Technical Information Bulletin**Excessive Reman Water Pump Shaft End Play May Occur on Certain C9 through C18 Engines {1361, 1389}**

Media Number -M0116039-00

Publication Date -2020/01/27

Illustration 1

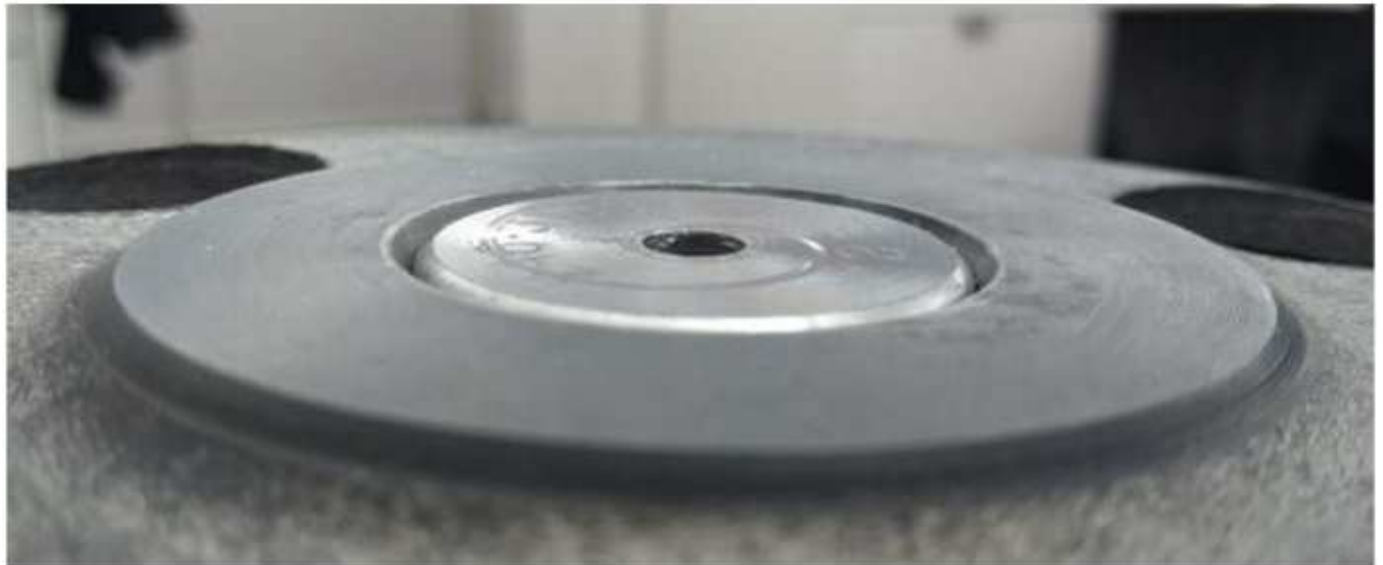
Incorrect gear placement on the shaft may lead to excessive axial end play resulting in leaks.

1. Inspect the area shown in Illustration 1 where the gear was installed on the shaft.
